REMARKS

Applicant has carefully reviewed the Official Action dated September 15, 2003 for the above identified patent application.

Tube-formed rock bolt

FIG. 4

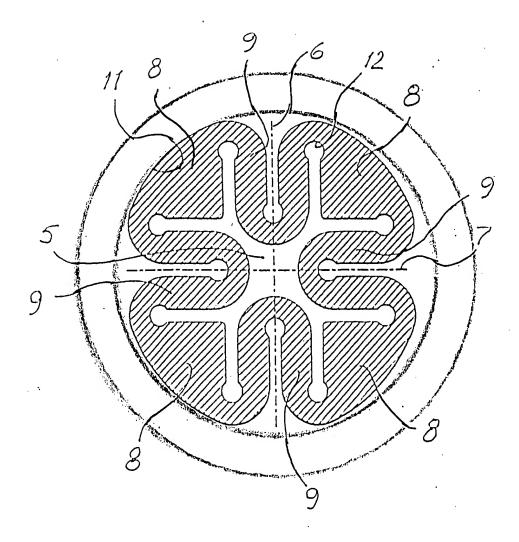
At page 2, paragraph 1 of the Official Action, the Examiner has objected to the drawing under 37 CFR 1.83(a) on the grounds that the drawing does not illustrate every feature of the invention specified in the claims. In response to this drawing objection, Applicant proposes to add FIGURE 4, a copy of which is enclosed for the Examiner's approval. The specification has also been amended to refer to and discuss newly added FIGURE 4. The addition of FIGURE 4, and the revision to the Specification discussing FIGURE 4, is supported by the disclosure of Claim 1, as originally filed. Original claims constitute original disclosure to a patent application, and both the drawings and the specification can be revised to illustrate and discuss features recited in an original claim without adding new matter to the application.
